BAR Meeting
July 1, 2015

ISSUE: New Construction: Buildings 1 and 2

LOCATION: 2 Duke Street

BAR 2015-0189 & BAR 2015-0190

BLDG 01 - OVERALL ELEVATIONS

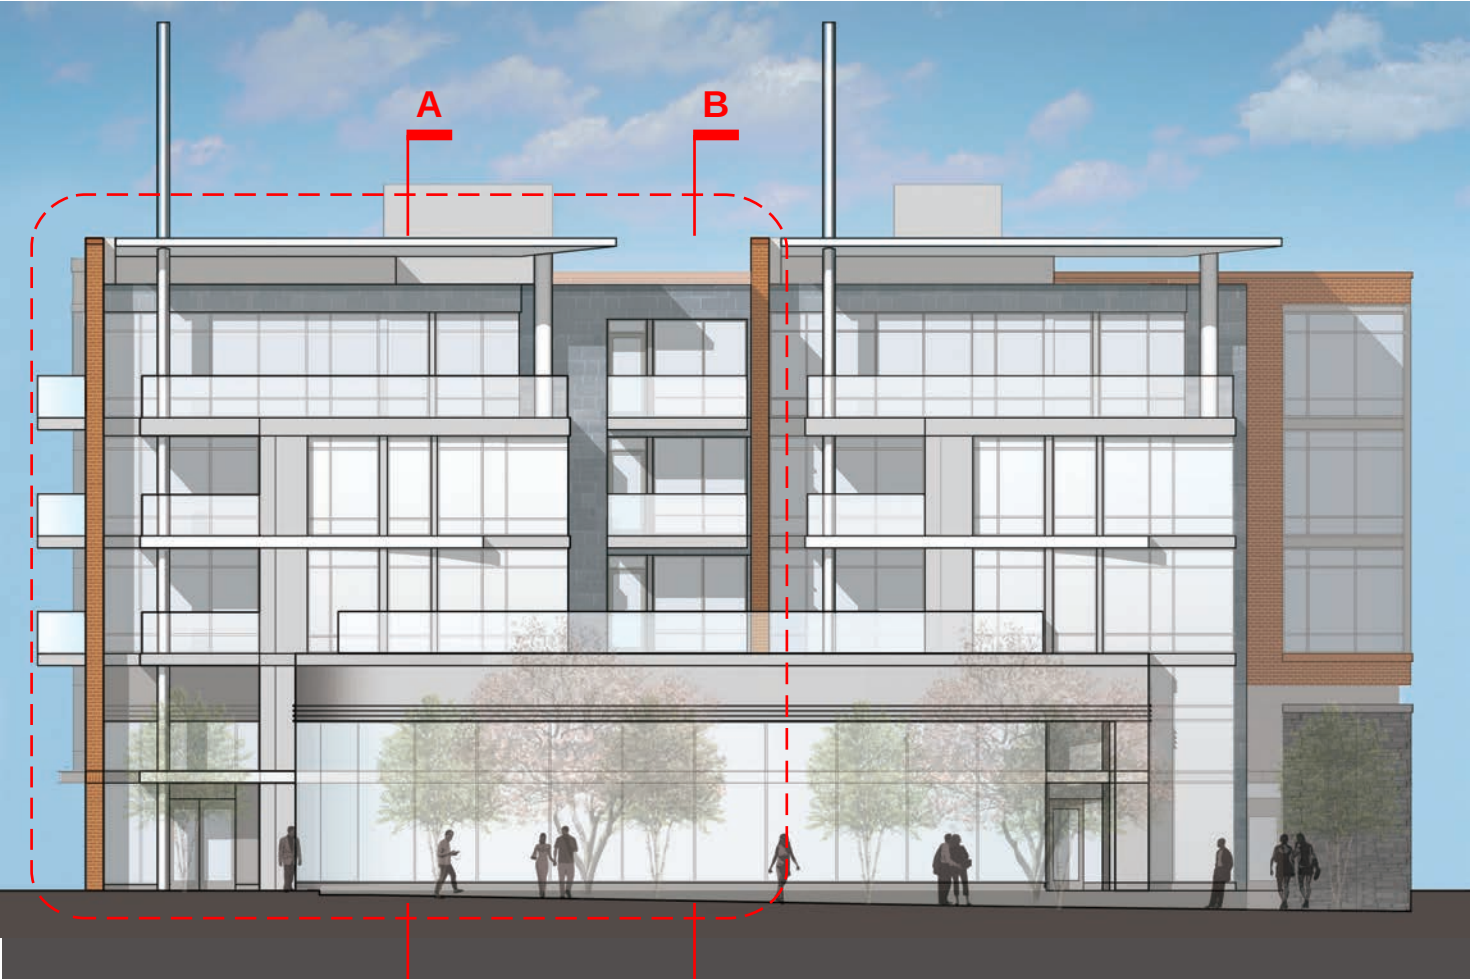
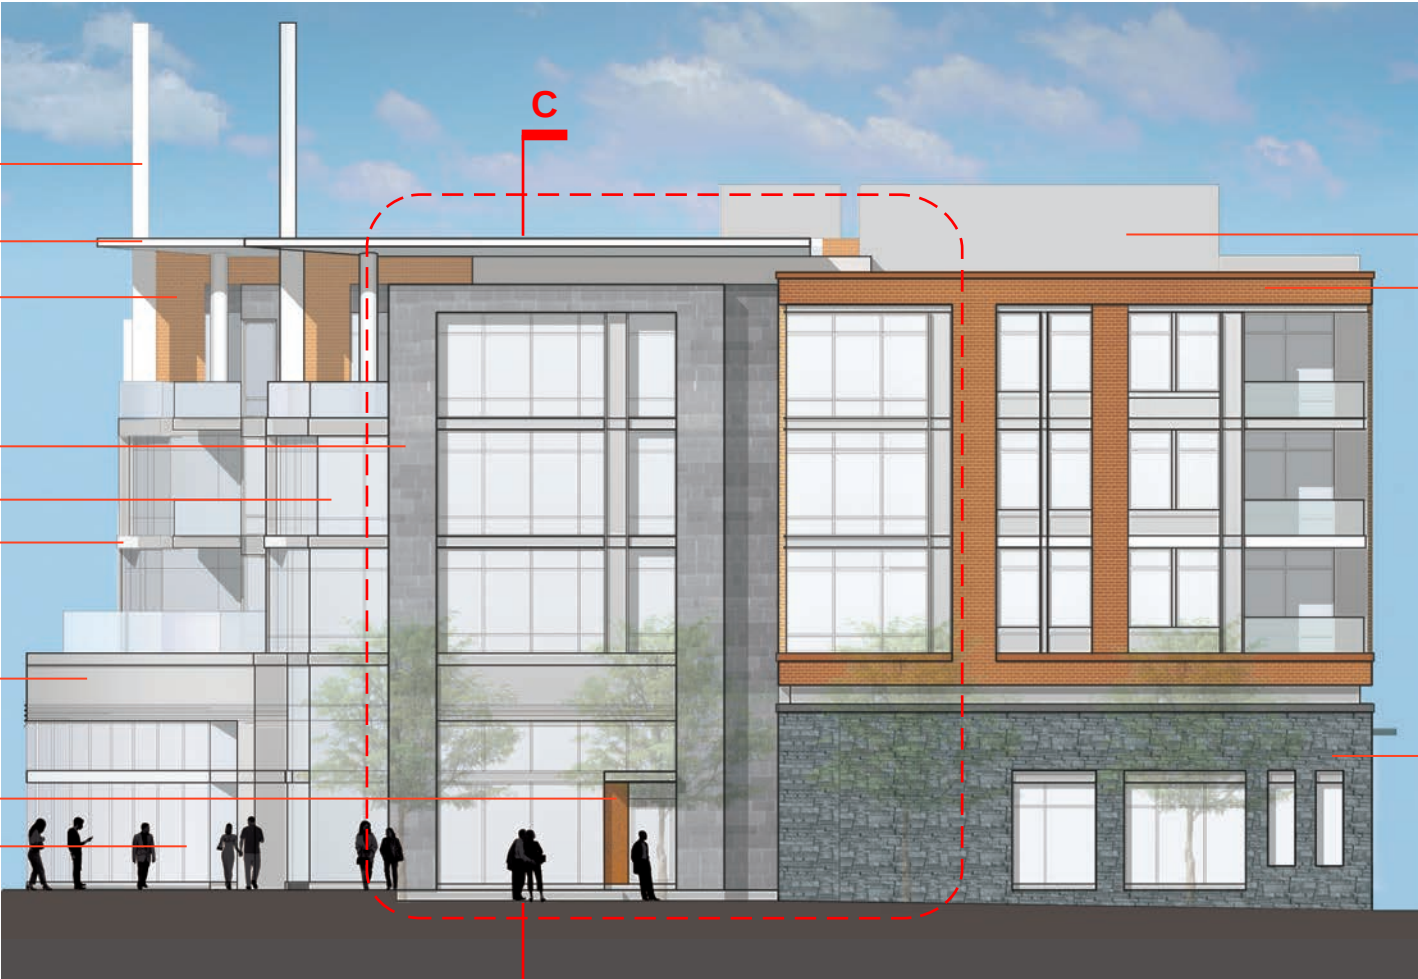
5. At Building 1:
 - a. The restaurant section at Building 1 should relate more to the building’s stylistic vocabulary and be integrated with the overall design composition, as well as create a strong presence on the north elevation reflecting this significant project cornerstone.

In addition, the BAR generally supported a curving glass form for the restaurant but wanted it to be more substantial, in order to be a signature feature and to read as a two-story space, reflective of the airy interior. The current design approach is capped by a heavy ribbed fascia band reminiscent of the Art Deco style that is somewhat foreign to the rectangular vocabulary of the rest of the building. Staff would prefer to see less of the ribbed metal banding and more glass, as the current proposal makes the restaurant's form seem like a disparate component that is not integrated with the overall design. Staff has no objection to the curved glass railing above the

fascia but finds that it will be better integrated if the area below has more glass and less metal panel. Such a change could also influence the east façade of the residential units above, further differentiating the waterfront elevations of Buildings 1 and 2.

BLDG 01 - ENLARGED WEST ELEVATION

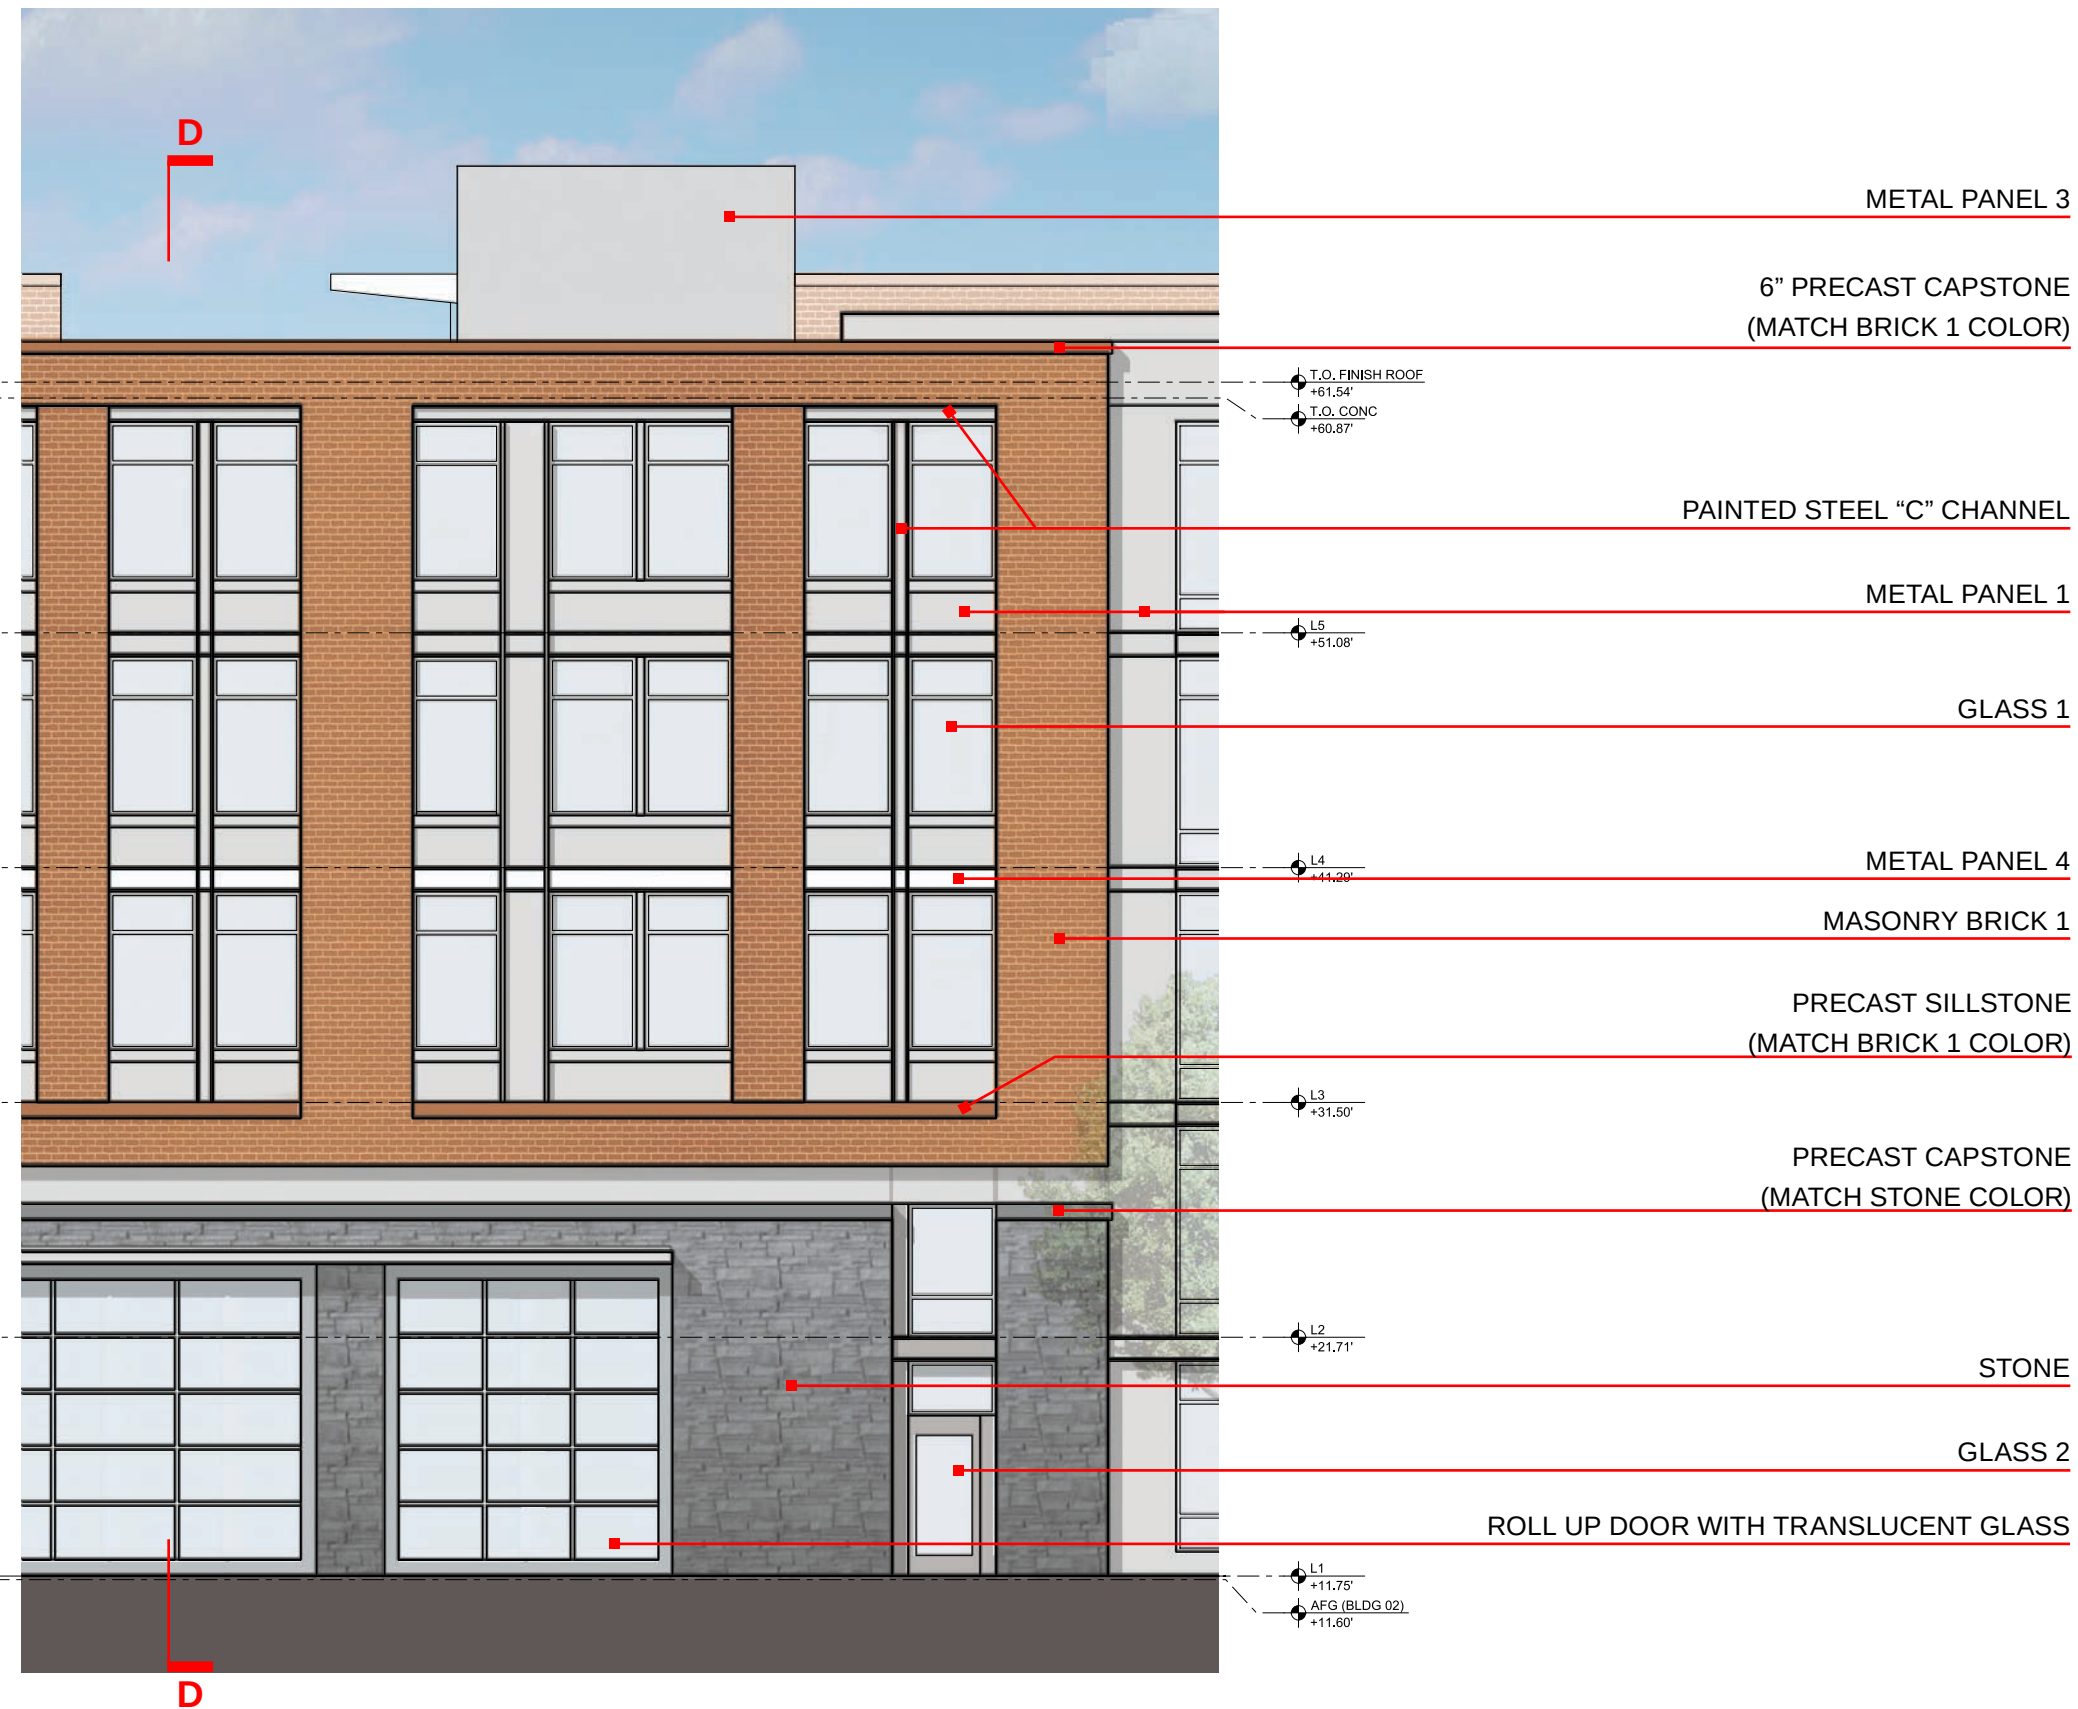
- b. Add more detailing and surface differentiation—such as banding applied with smooth cut stone—within the stone base to break up the solid two-story stone wall.

- c. Select a stone lighter in color and with a more random rustic rubble configuration, similar to that at Fitzgerald’s Warehouse.
 - d. Remove the awnings above the garage doors and recess the garage and loading doors.

The concept of the substantial stone base at Building 1 is appropriate and represents a thoughtful response for how to design a contemporary building that is *of Alexandria*. However, as drawn, the stone element appears too dark in color and to be cut in a way that is foreign to Alexandria's historic building foundations. Staff recommends a local stone that reflects the colors found in the exposed foundation at Fitzgerald's Warehouse that are lighter and warmer, as well as with a more traditional fieldstone arrangement with natural stones set in a range of sizes. One way to then add a contemporary interpretation, as well as break up what is effectively a two-story stone wall in some parts, is to add one or two bands of a smooth cut stone that may be designed as a belt course or water table. Alignment of the stone belt course with the projecting canopy and lintels above the variety of openings at the first floor of the west elevation could also very subtly tie disparate openings together. Such an approach would combine the reference to historic materials but also acknowledge that this is a new approach and new building.

Building 1 is a building without a “back” as the west elevation is on The Strand and will be a significant walking street despite the locating of the garage entry and loading dock on this elevation. Staff recommends a clean approach to this area and advises removal of the small canopies and the use of translucent doors within a more pronounced recess to reflect that these are large openings within a masonry wall.

BLDG 02 - ENLARGED SOUTH ELEVATION

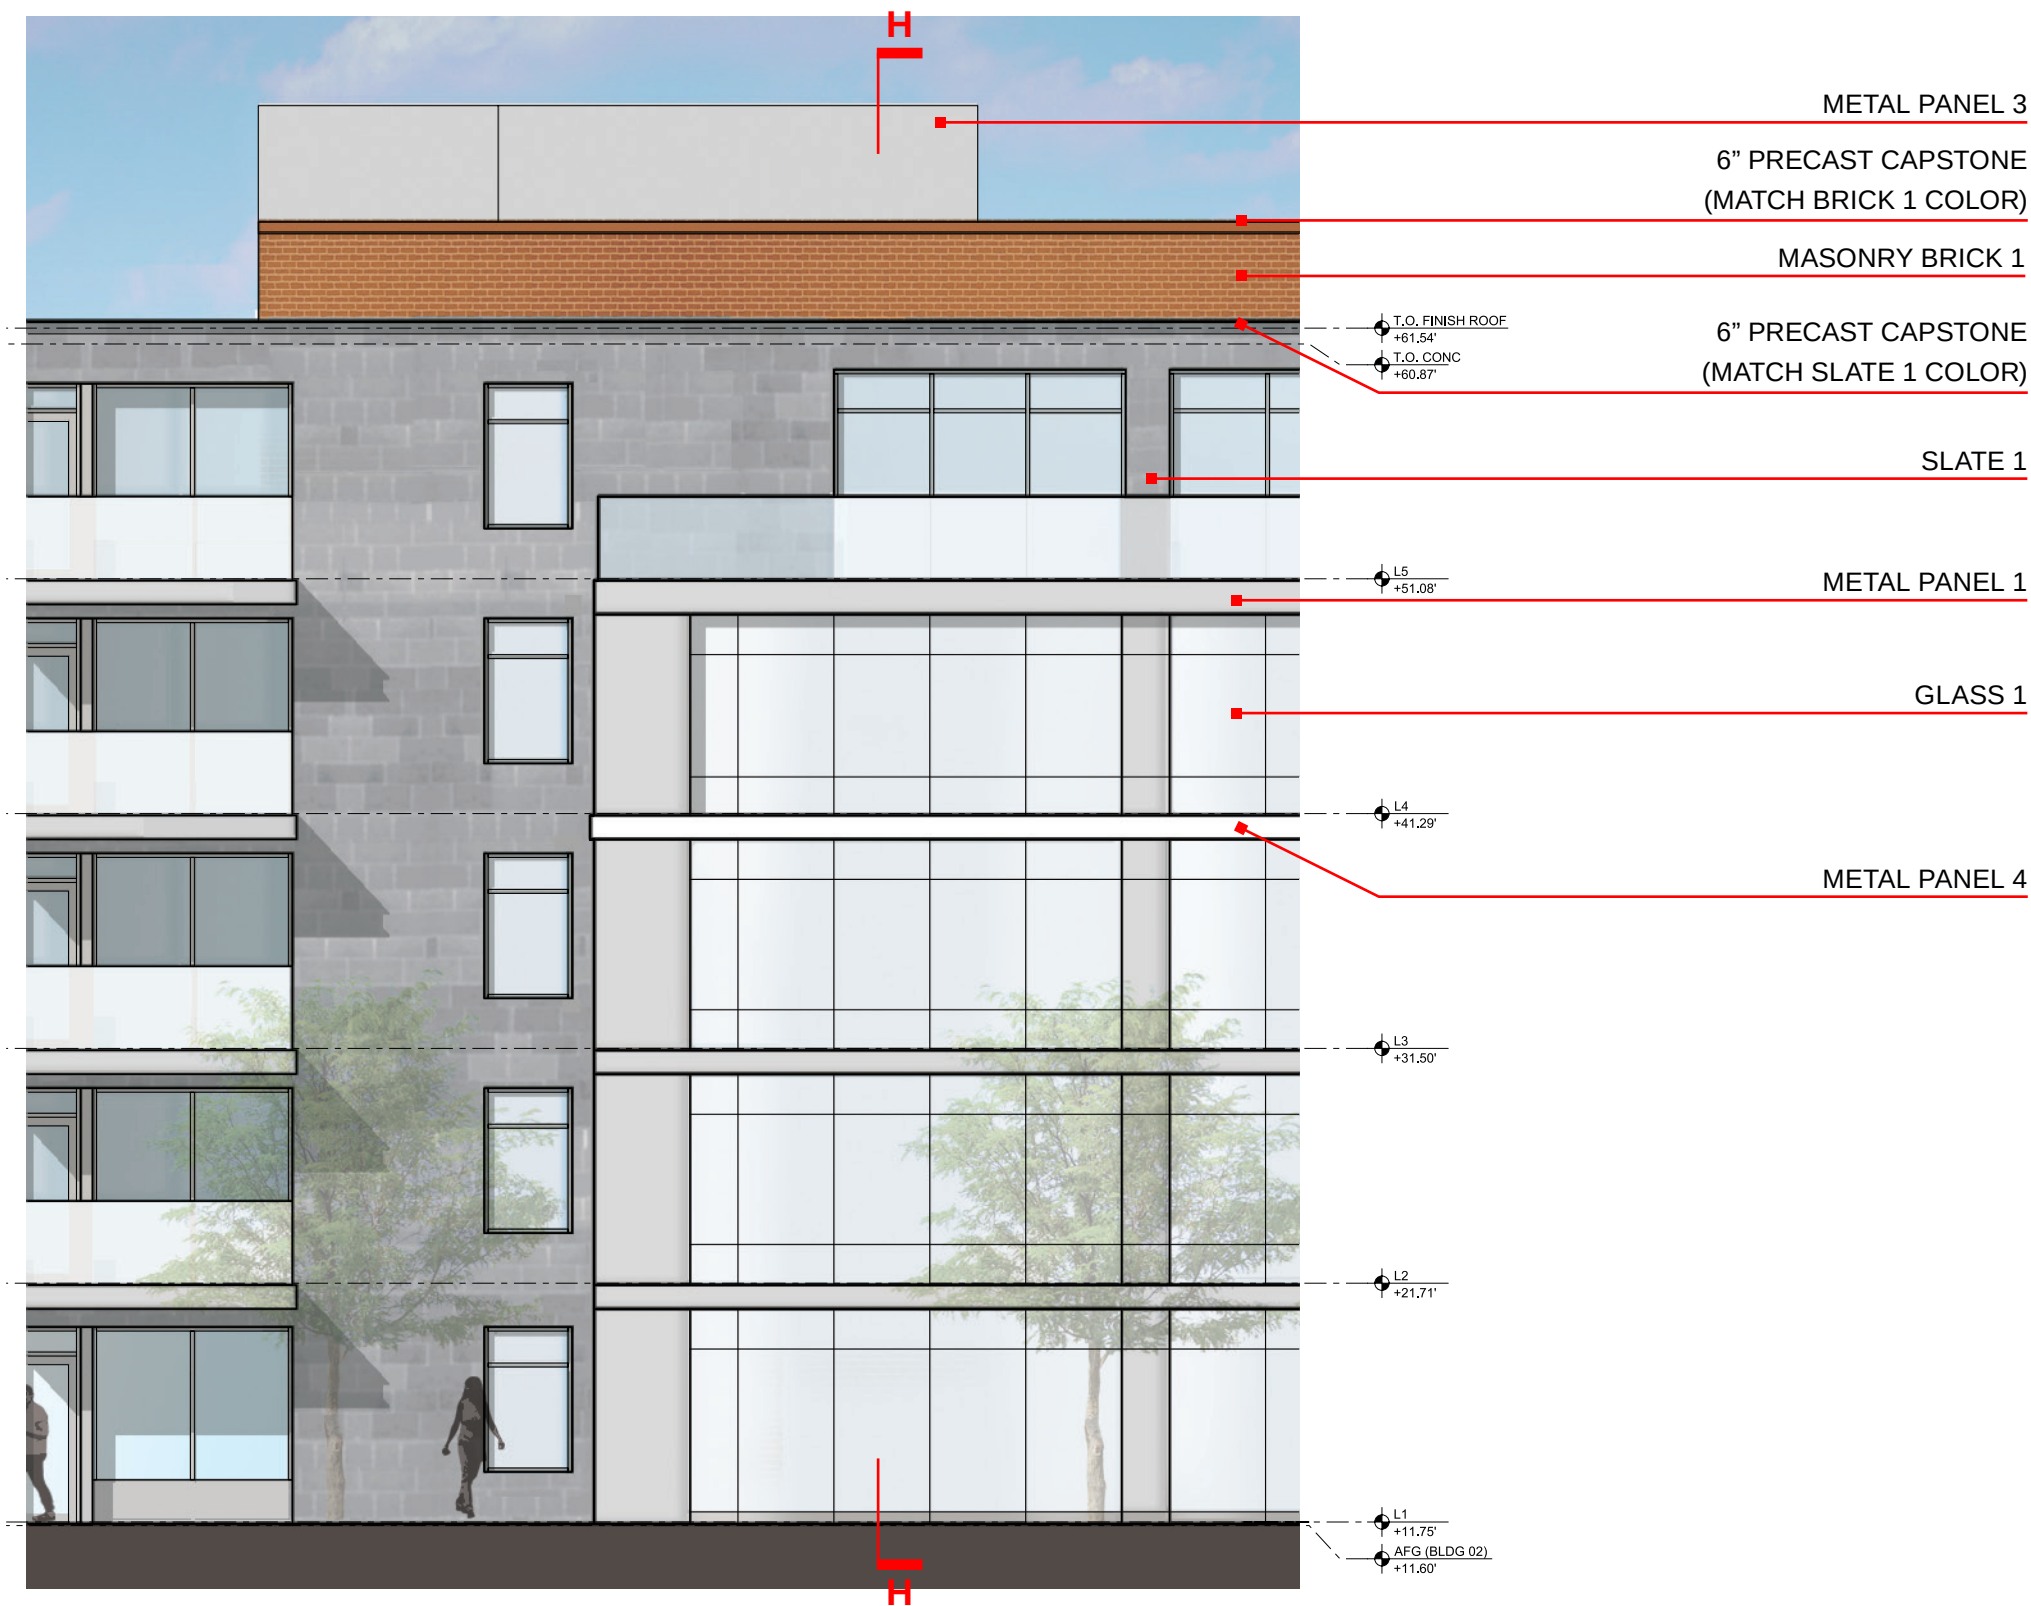
6. At Building 2:
 - a. Add brickwork and sunscreens to the south elevation to better relate to other elevations.
 - b. No residential doors are permitted at the first floor on the waterfront elevation.

In general, Building 2 is quite successful and the applicant should continue in this design direction. While the rear elevation, which features substantially more brick than the other three elevations, may appear repetitive, staff notes that it will only be visible in relatively small segments through the various alleys and paths and will have meaningful streetscape improvements including street trees. However, the south elevation of this building needs further refinement. Staff notes that it is the only elevation of the two waterfront buildings without any brick. While not the sole cause, the lack of brick here does contribute to a stark appearance to this elevation. Therefore, in keeping with the other patterns of how brick is used on these two buildings, staff recommends that the wall immediately to the east of the central balconies be brick. Additionally, to soften this elevation and relate the residential character of this part of the building, a solid sunshade should be considered at the fifth story that would wrap around slightly to the waterfront. The addition of this element would further distinguish Building 2 from Building 1 while adding an interesting architectural feature.
